MOUNTING MODIFICATION CD80255

Picture #1: Changes to condenser mounting design

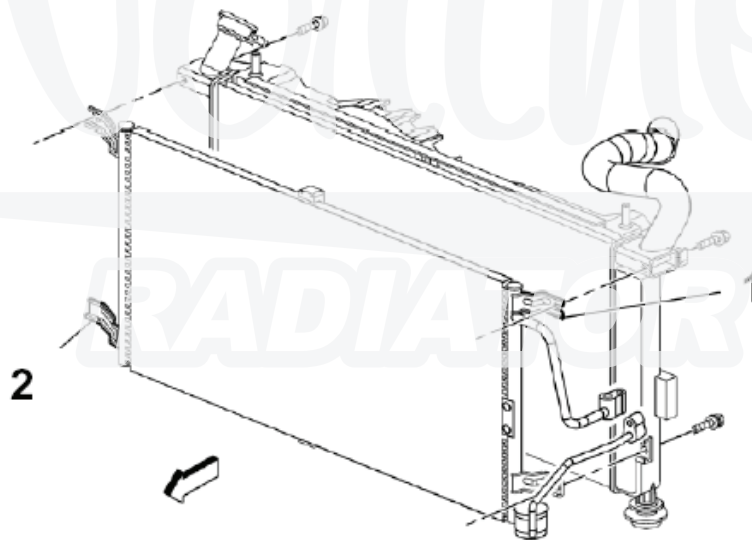
When installing your new Northern condenser, you will see that the condenser-to-radiator mounting may be different when compared to the condenser that you are removing from your vehicle. This sheet will identify those differences, but rest assured that these changes are intentional and are intended to increase the service life of your new Northern condenser. Previously the OE manufacturer found that the condenser's original mounting design/configuration was the reason for many premature failures. This mounting style constricted the condenser and resisted the expansion and contraction of the condenser caused by it warming up and cooling down (thermal cycling). This resulted in extreme stress being applied to the tube-to-manifold joint, which caused the joint to leak (stress fracture). Imagine bending a paperclip back and forth repeatedly, eventually the paperclip breaks. This is what happened to the tubes at the tube-to-manifold joint. The OE manufacturer resolved this problem by adding a slot to the upper right mount (#1 in diagram) and removing a bolt from the bottom left mount (#2 in diagram). To help ensure that our part would not fail prematurely for the same reasons, we followed the OE manufacturer and made the same changes. If you have any questions or require further assistance, please contact your local Northern Branch office.
